INSTRUMENT REFERENCE BOOK

for the Tektronix type

315D

MODIFICATIONS

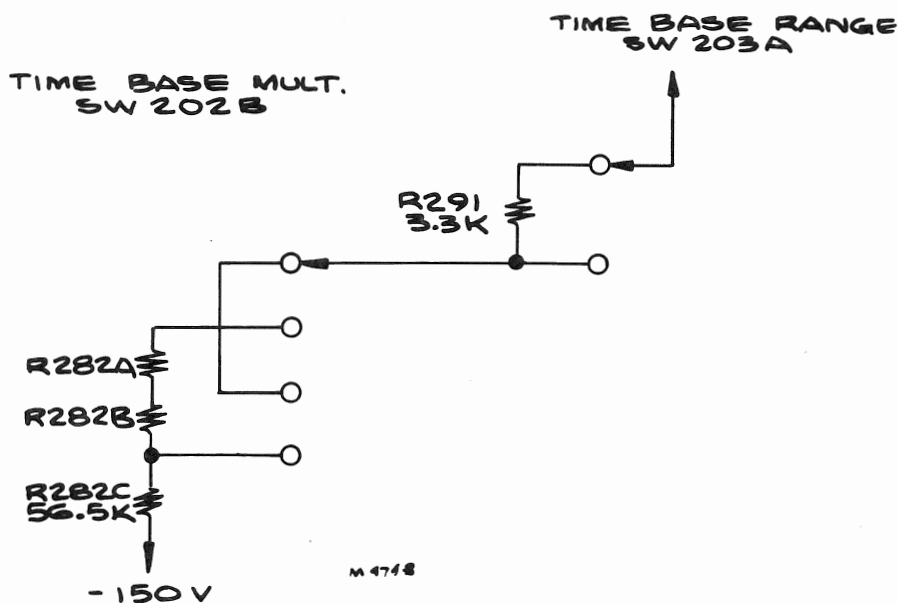
- C272 (at pin 1 of V213A) from 22 pF to 47 pF
- C276 (at pin 6 of V214B) from 3-12 pF to 1.5-7 pF
- C303 (at pin 3 of V224A) from 4.7 pF to 0.5-5 pF
- R282C (on Time Base Multiplier switch) from 60 k to 56.5 k 1%
- Remove C300 (near V222)
- Add R291 to Time Base Range switch as shown in schematic

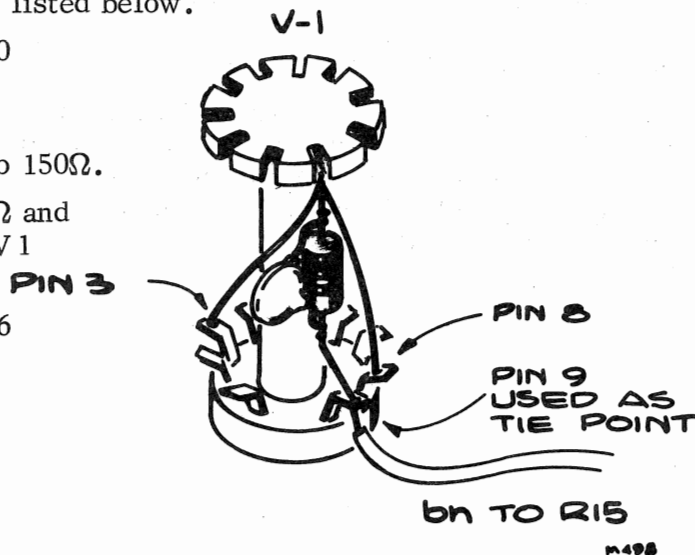
Preamplifier transient response improved by:

- a) Change R36 (across L2) from 220 Ω to 150 Ω .
- b) Install a network of R16 and C16 (10 Ω and 0.02 μ F in parallel), in series with V 1 cathode lead to R15. See drawing.
- c) Install C13, 0.01 μ F discap from pin 6 of V2B to ground.
- d) Recalibrate Vertical Preamplifier.

FIG. 1

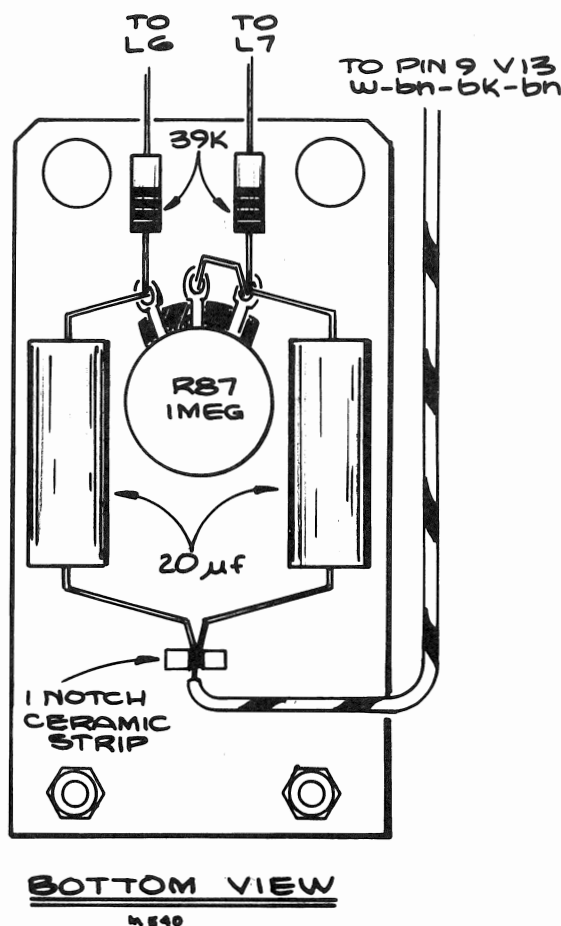
To compensate for vertical DC shift, add an LC network to the plate circuit of the Vertical Amplifier output tubes.

- Mount and wire parts on mounting plate 386-0323-00 as indicated in Fig. 1.
- Change R80 (at L4 and L6) and R84 (at L5 and L7) from 2.5 k 10 W to 2.7 k 10 W.

FIG. 2

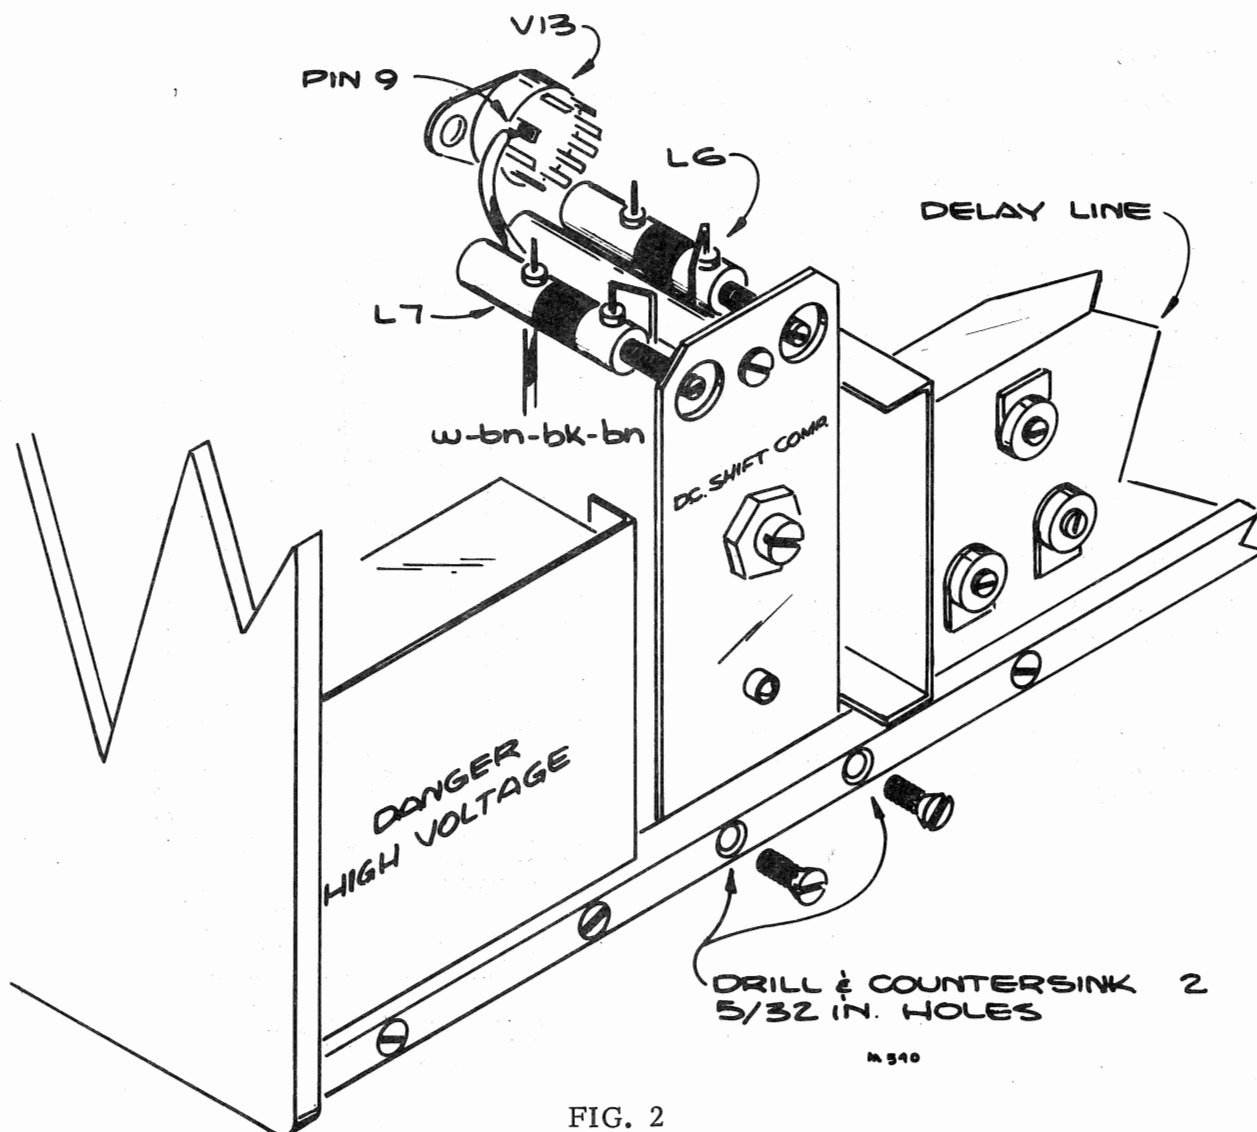
- c) Mount the DC Shift Comp plate to the support bar above the CRT socket as shown in Fig. 2.
- d) Wire as shown in Fig. 2.
- e) Refer to your Instruction Manual and adjust L3, L4, L5, L6 and L7.
- f) Set the DC Shift Comp control as follows: Set the AMPLITUDE control to the DC 0.1 VOLTS/DIVISION position and the MULTIPLIER to 2. Advance the STABILITY control until the time base is free running and center the trace vertically. Connect a lead from CAL OUT to INPUT and switch the CALIBRATOR control alternately from the OFF position to the 1-volt position. Adjust the DC Shift Comp control, R87, until the base line of the display does not shift position as the calibrator is switched off and on.

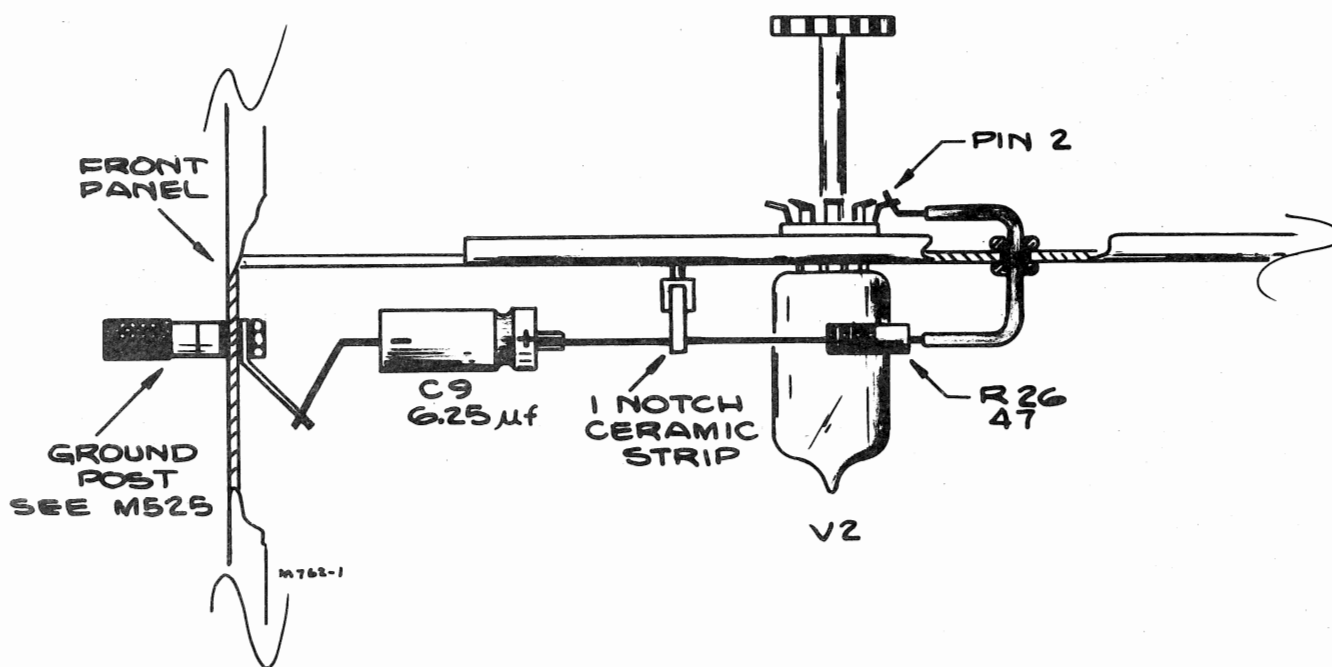
Refer to drawing and rewire C9, (6.25 μ F) and add R26 (47 Ω).

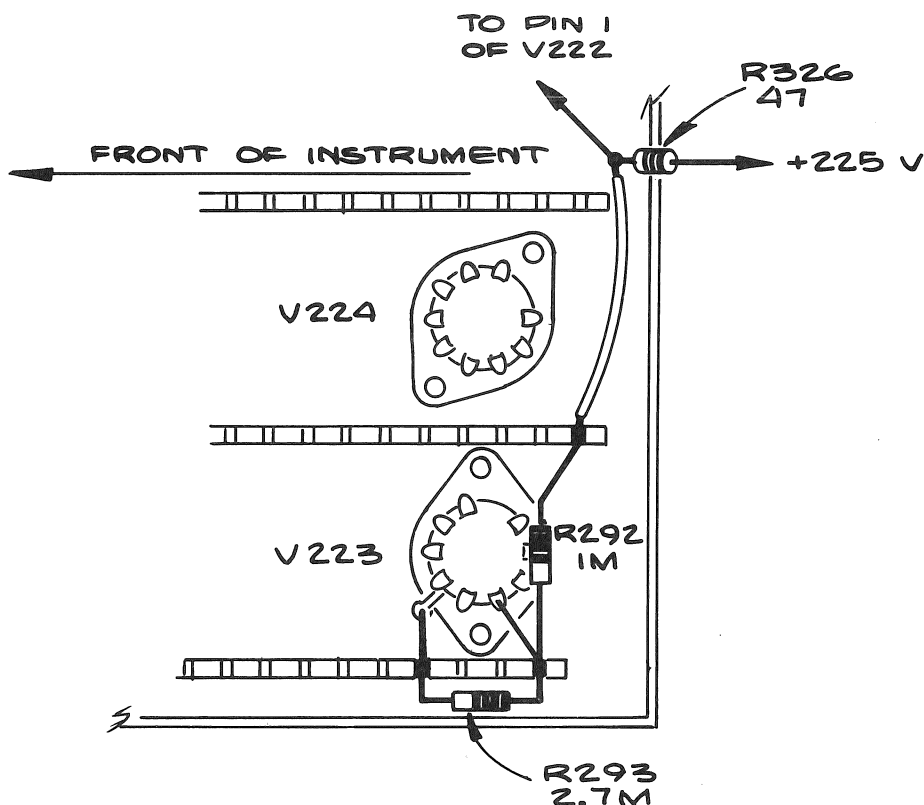
- Remove strap between V442, pins 3 and 8.
- Remove strap between V442, pin 8 and 270 k 1/2 W resistor - white-red-red-black wire junction.
- Add strap between V442 pin 3 and 270 k 1/2 W resistor - white-red-red-black junction.
- Add R292, 1 M and R293, 2.7 M as shown in drawing on next page.

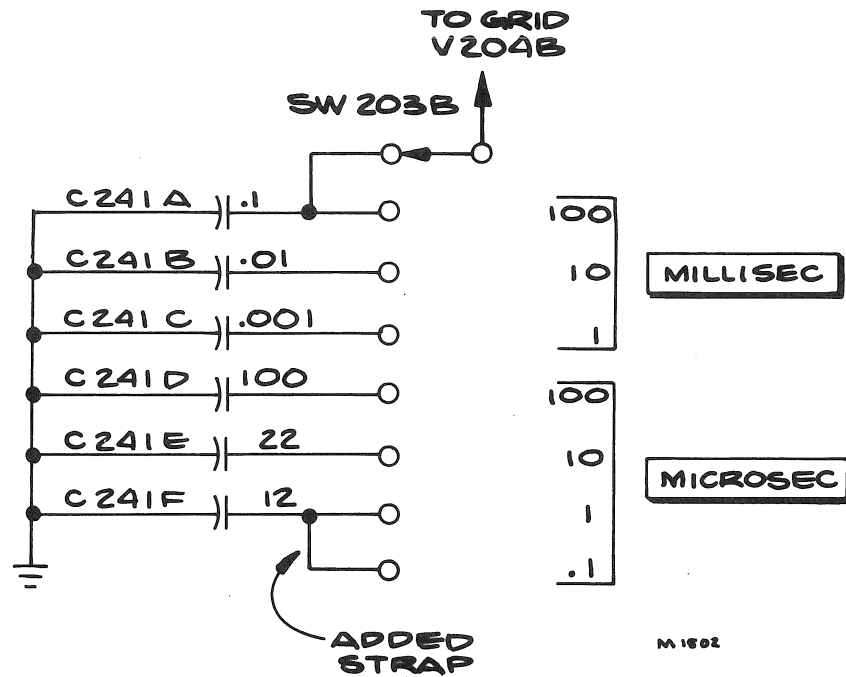
To overcome shrinkage in the sweep waveform at the fastest sweep range with a free running-untriggered-sweep. The problem was due to inadequate hold off time in the 0.1 MICROSEC position, and was cured by adding a strap between the 1 and 0.1 MICROSEC positions of SW203B.

Add a wire strap between the 1 and 0.1 MICROSEC positions of the Time Base Range switch SW203B. See schematic on following page.

Fig. 2

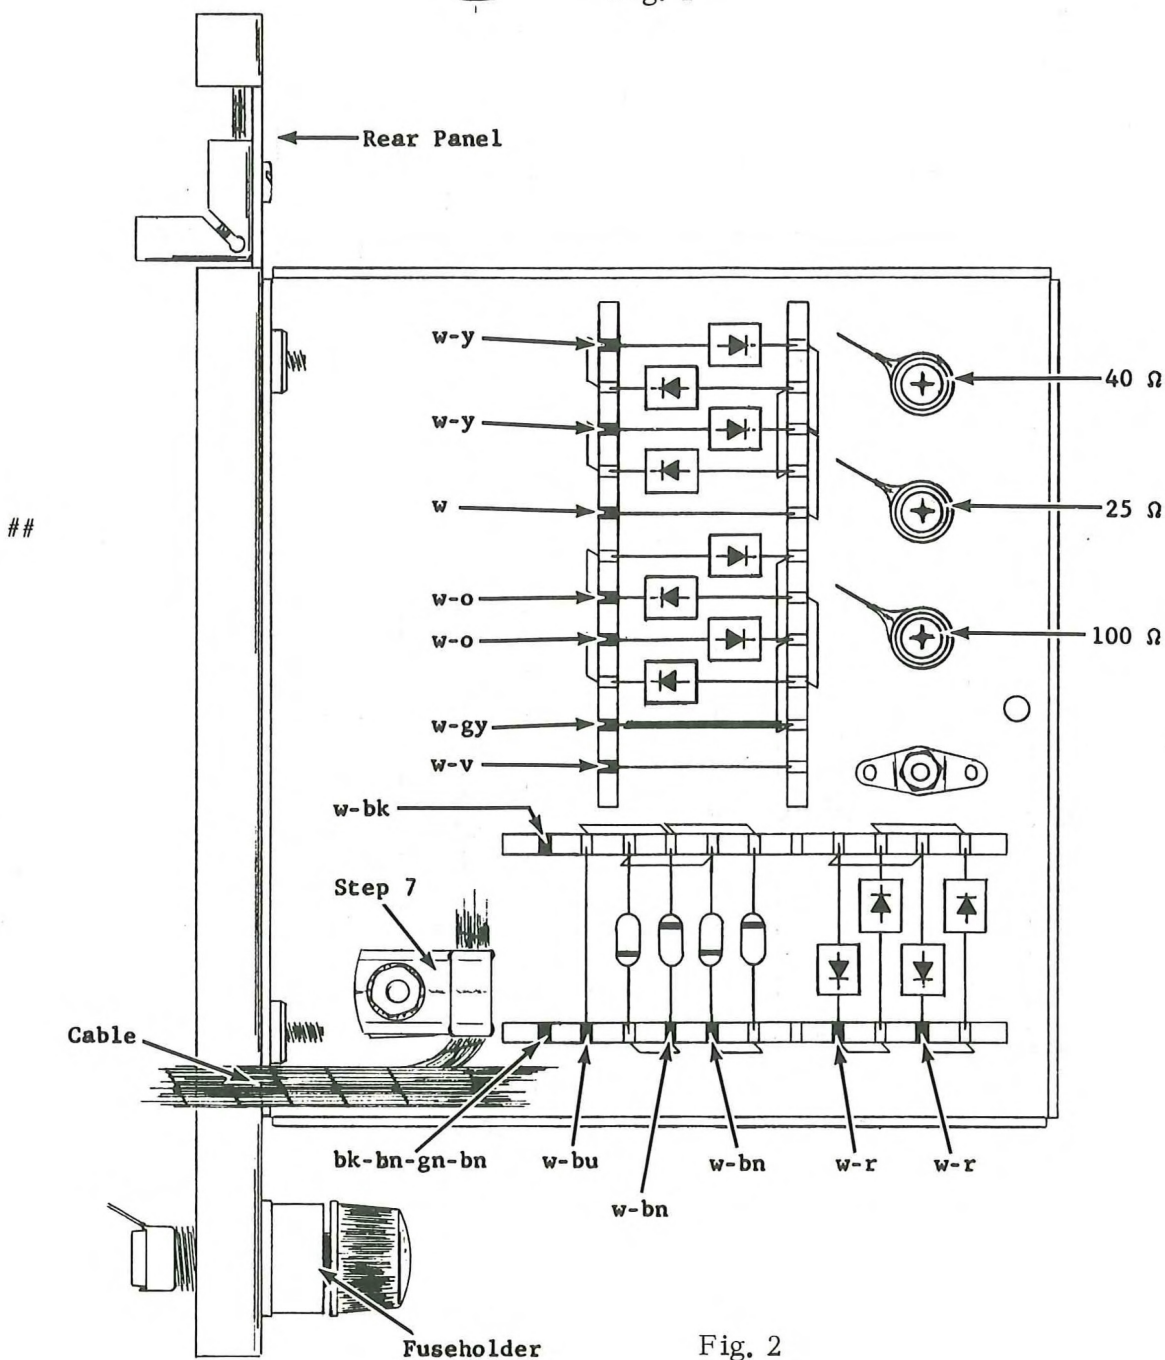
- () 1. Remove the selenium rectifier mounting plate from the instrument.
- () 2. Unsolder all wires to the selenium rectifiers.
- () 3. Temporarily mount the silicon rectifier assembly on the back panel of the instrument (as shown in Fig. 2) with the two 6-32 x 5/16 screws from the kit.

- () 9. Solder the wires to the ceramic strips, as shown in Fig. 2.
- () 10. Locate R443 and R465 (top of instrument, at rear). Replace them with the resistors (from kit) indicated below. Use the old mounting hardware.

FIG. 1

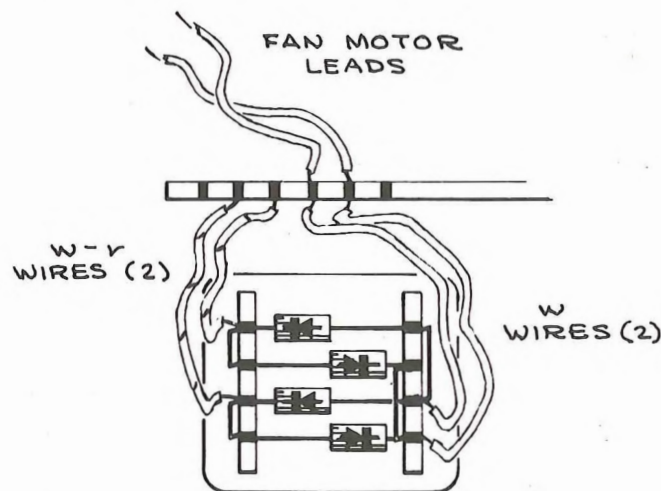
- ## A. TO REPLACE SELENIUM RECTIFIER IN THE FOLLOWING INSTRUMENTS: See Fig. 1
Type 515 SN 101-1000; Type 515A SN 1001-4029
- () 1. Replace the selenium rectifier on the Power chassis with the assembly from the kit. Position the assembly as shown, using a lockwasher (from kit) between the assembly and the chassis.
 - () 2. Solder the two white and two white-red wires (from kit) between the assembly and the adjacent ceramic strip as shown.

FIG. 2

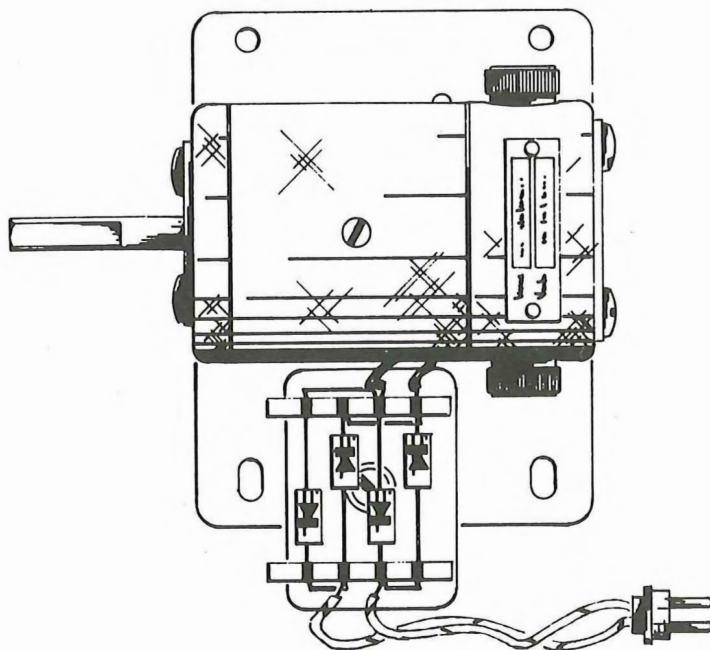
B. TO REPLACE SELENIUM RECTIFIER IN TYPE 315D: See Fig. 2
